**HYDE PARK CITY  
CITY HALL WELL HOUSE AND TRANSMISSION LINE  
ADDENDUM #1**

**FEBRUARY 13, 2025**

This Addendum #1 covers the following items:

FILE: 57-14-034 - C-201X  
 JUB PROJ. #: 57-14-034  
 DRAWN BY: ELC  
 DESIGN BY: MTS  
 CHECKED BY: ZPM  
 AT FULL SIZE, IF NOT ONE INCH, SCALE ACCORDINGLY  
 LAST UPDATED: 11/15/2016  
**SHEET NUMBER:  
 C-210**

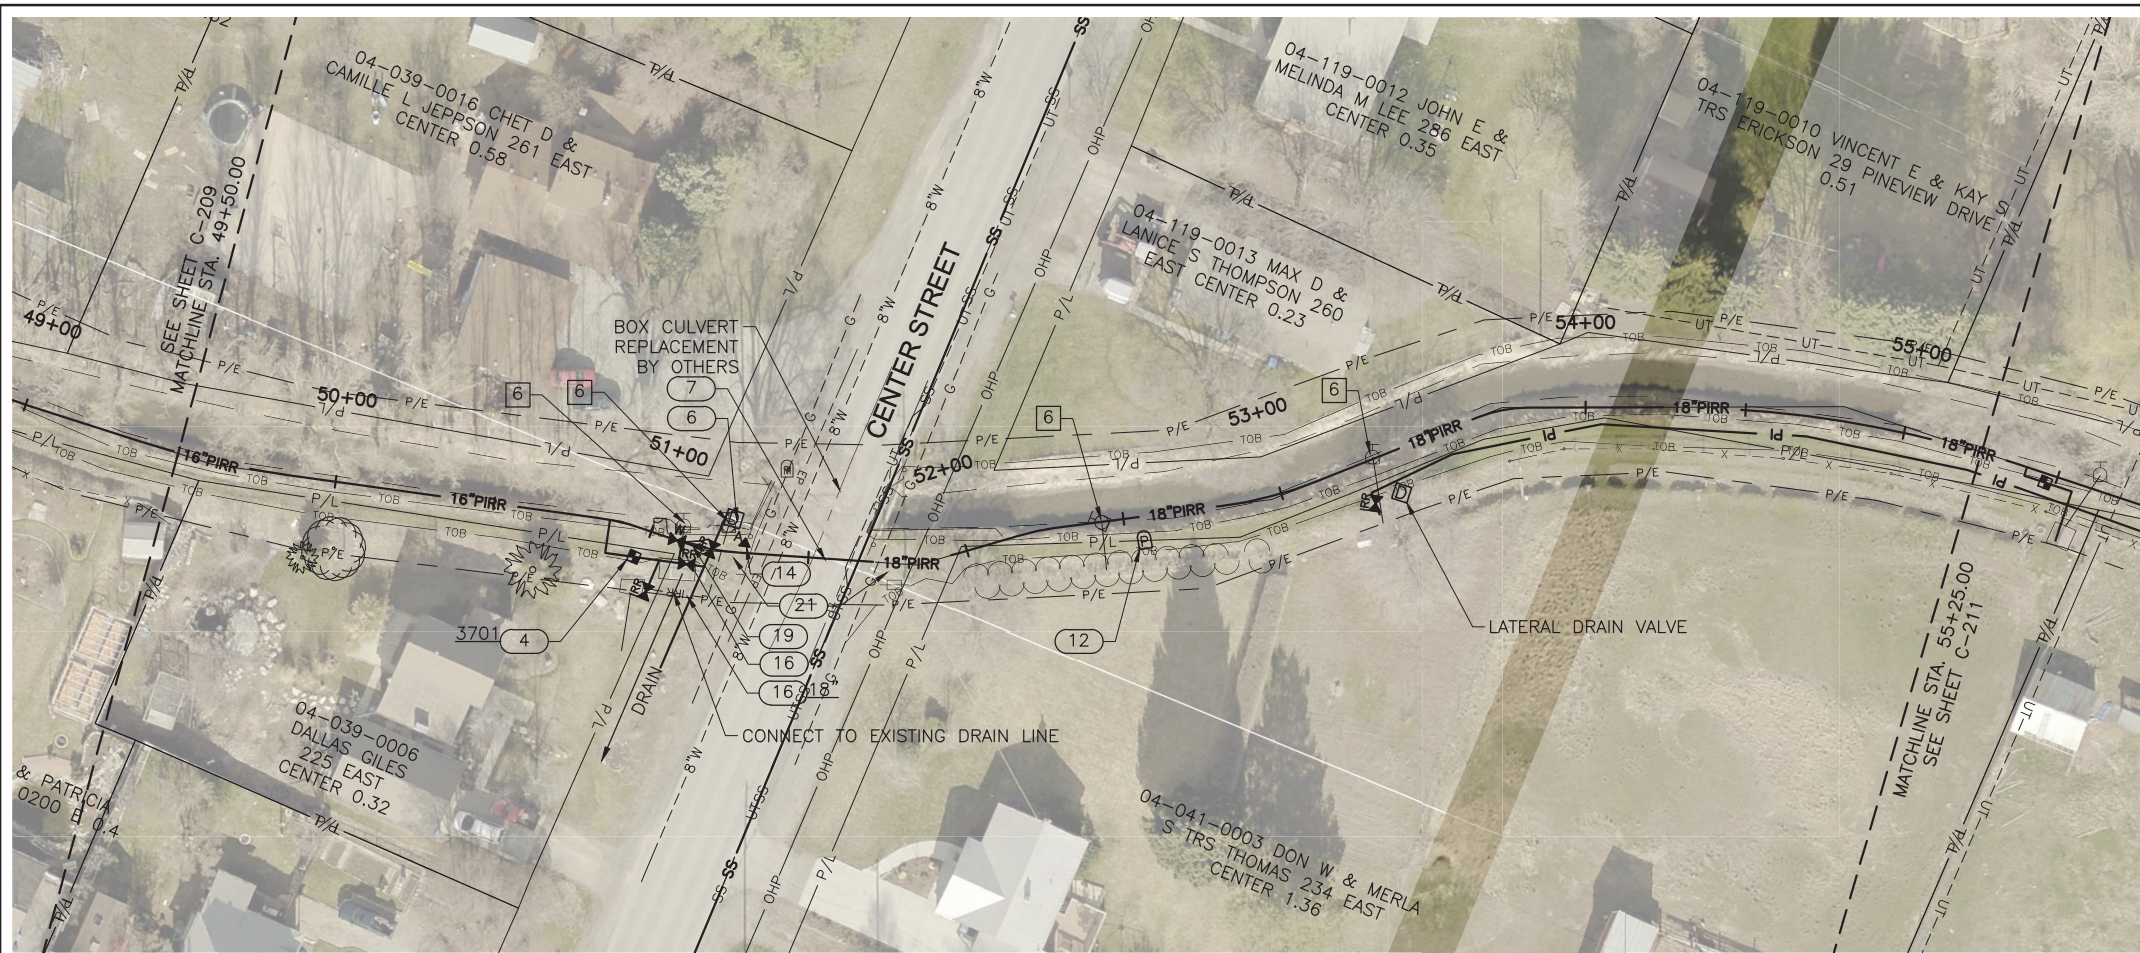
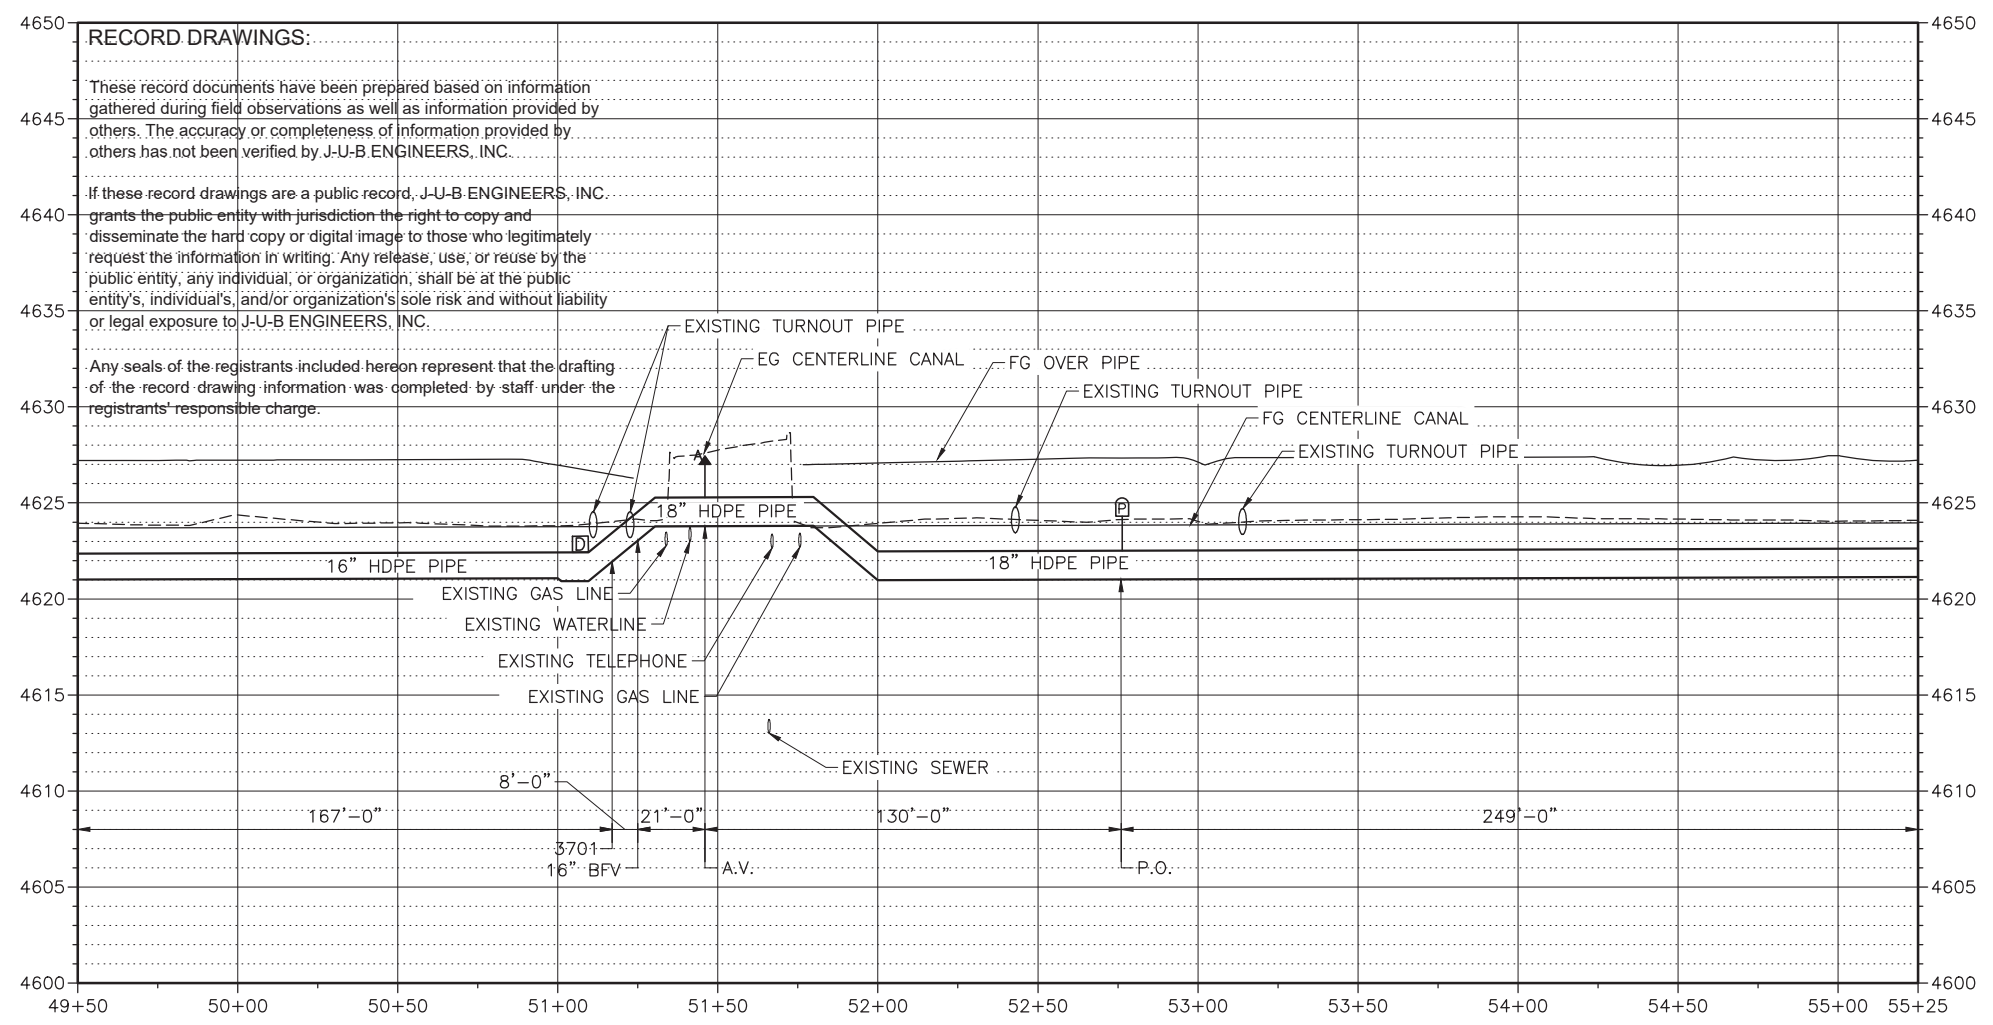
Q: Please provide more information on the canal crossing part of the project. Is there a buried pipe next to the canal?

A: The canal that is being crossed does have an adjacent 18" HDPE pressurized irrigation pipe. The actual canal is used for stormwater conveyance. Attached to this addendum will be a record drawing for the pressurized irrigation pipe as it crosses center street. Prior to the bore, the contractor will be required to locate the pipe to ensure that the bore is 5' beneath the pressurized irrigation pipe.
